Access Compliance Report

Public Rights-of-Way

(Curb Ramps)

Intersection ID: 3053	Main Street: WHITE_STAG_DR	Cross Street: WHITETAIL_CT	Location: NE
ADA ID: E8774FFB85BA	Ramp Type: Perp	Initial Pass/Fail: Fail	Overall Compliance: No
Severity Score: 10			
Codes/Mitigation Info/Possible Solution		Field Measurements/Component Compliance

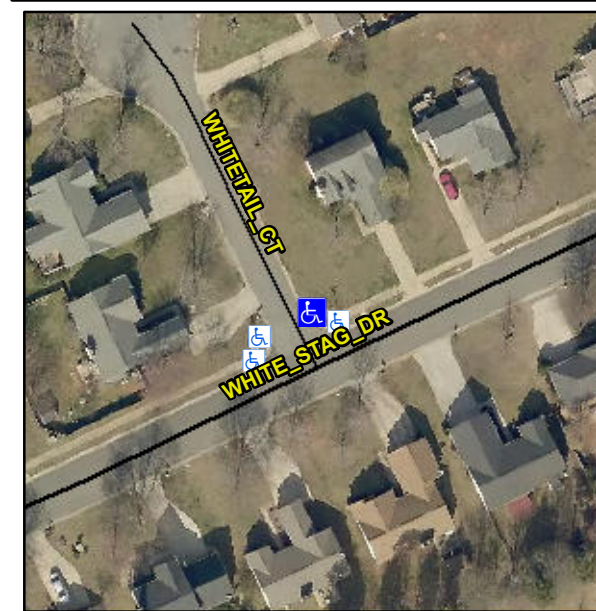
Not Found, R304.5.1, R304.5.3

Compliance	Description	Data	Compliance	Description	Data
N/A	Ramp Length (in)	46.0	Yes	Ramp Slope (%)	8.2
No	Ramp Width (in)	41.0	No	Ramp XSlope (%)	3.0
N/A	Flare Type LT	N/A	N/A	Flare Type RT	N/A
N/A	Flare Slope LT (%)	N/A	N/A	Flare Slope RT (%)	N/A
N/A	Flare Traversable LT?	N/A	N/A	Flare Traversable RT?	N/A
N/A	Landing Length (in)	N/A	N/A	DWS Provided?	N/A
N/A	Landing Width (in)	N/A	N/A	DWS Contrast?	N/A
N/A	Landing Slope (%)	N/A	N/A	DWS Length (in)	N/A
N/A	Landing X Slope (%)	N/A	N/A	DWS Full Width?	N/A
N/A	Landing Curb? (Y/N)	N/A	N/A	DWS Offset (in)	N/A
N/A	Shared Landing?	N/A			
N/A	Gutter Ponding?	N/A	N/A	Gutter Slope (%)	N/A
N/A	Gutter Lip Ht (in)	N/A	N/A	Gutter X Slope (%)	N/A
N/A	Painted X Walk1?	No	N/A	Painted X Walk2?	N/A
	X Walk 1 Direction	To W		X Walk 2 Direction	N/A
N/A	X Walk 1 Width (in)	N/A	N/A	X Walk 2 Width (in)	N/A
	X Walk 1 Slope (%)	1.6		X Walk 2 Slope (%)	N/A
	X Walk 1 X Slope (%)	0.6		X Walk 2 X Slope (%)	N/A

Remove & Replace Entire Ramp.
